Planning and Zoning Commission
January 20, 2022
Agenda
Meeting Held Electronically due to COVID-19
5:30 P.M.

1. Project # 20-1009: Autumn Park Plat 7 – Final Plat

TO: Planning and Zoning Commission
FROM: Evann Martin, Assistant Planner
DATE: January 20, 2022
RE: Autumn Park Plat 7 – Final Plat

RE: Autumn Park Plat 7

AUTUMN PARK PLAT 7
FINAL PLAT

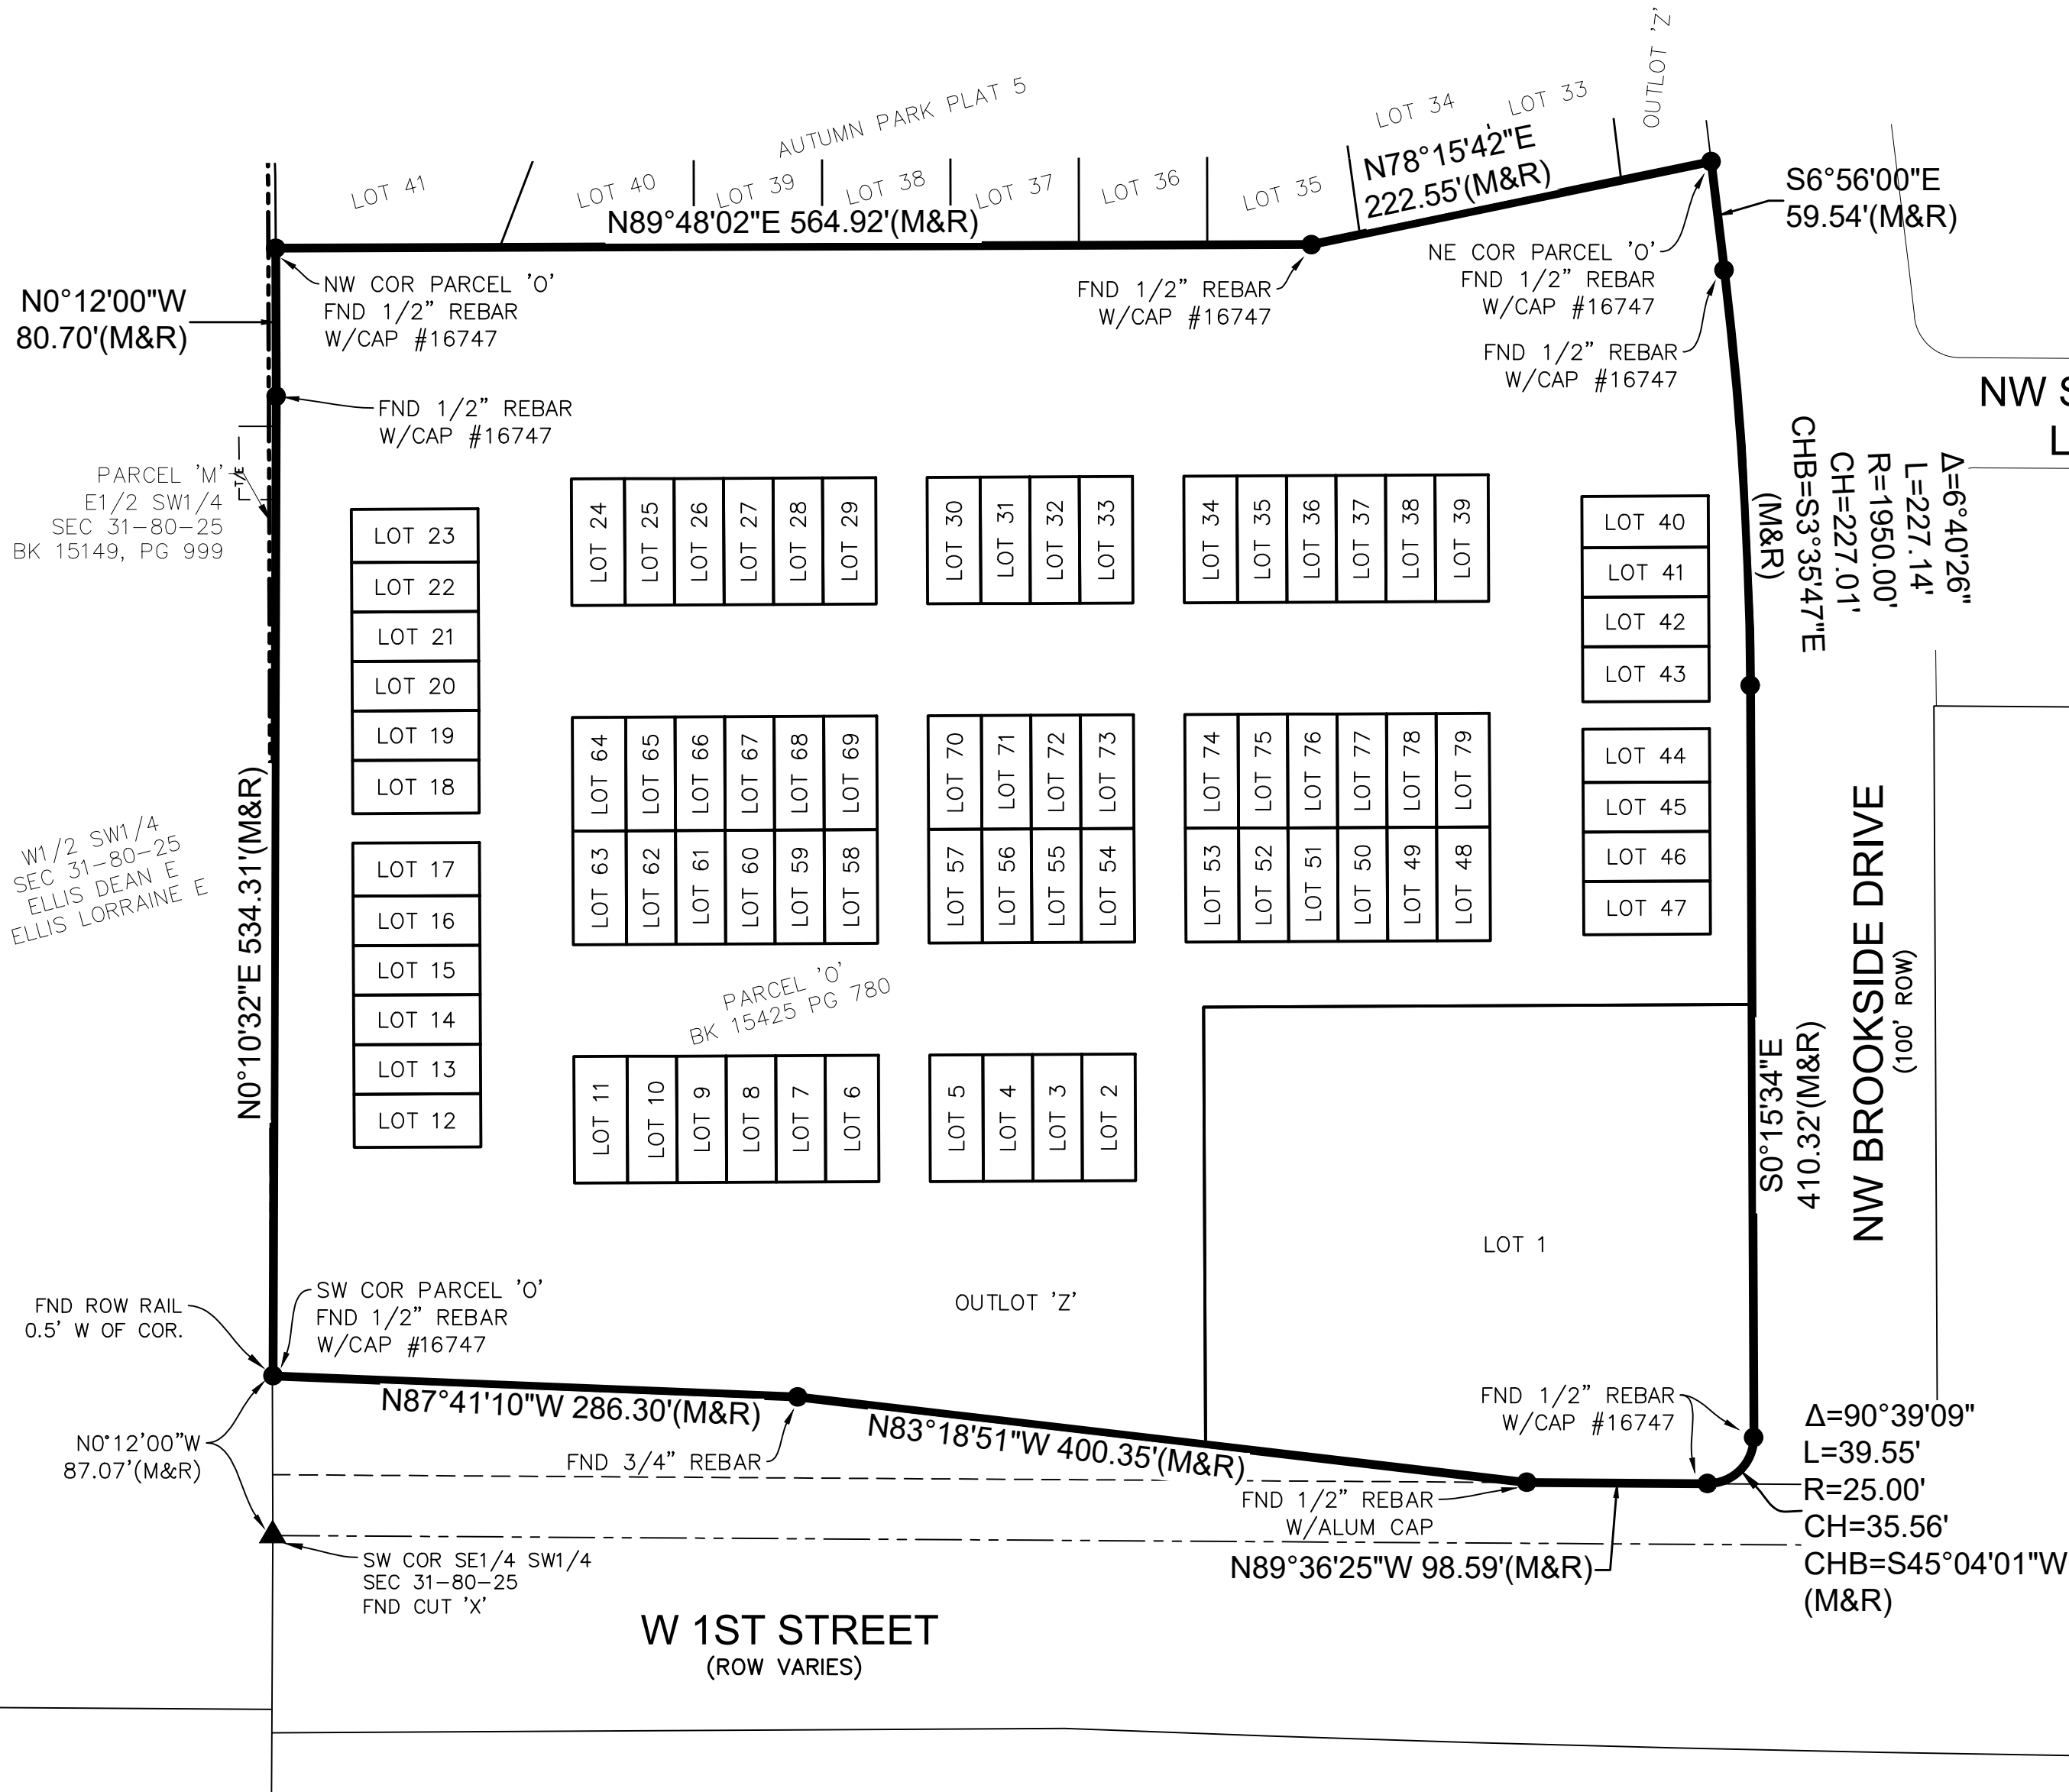
11. On the plat, please provide a curve table.
12. Label the street names and addresses.
13. Provide landscape buffer easement document.
14. Please adjust the title of the easements so they match on both the easement documents and on the plat. For example, the plat says access/utility easement and the easement document says public access and utility easement.

15. On the plat, at Lot 39, please label the water main easement as 10.00' water main easement.
16. On the PUE easement document, the legal description doesn't quite match the plat.

17. Label private storm sewer and overland flowage easements to match the proposed changes to the site plan.
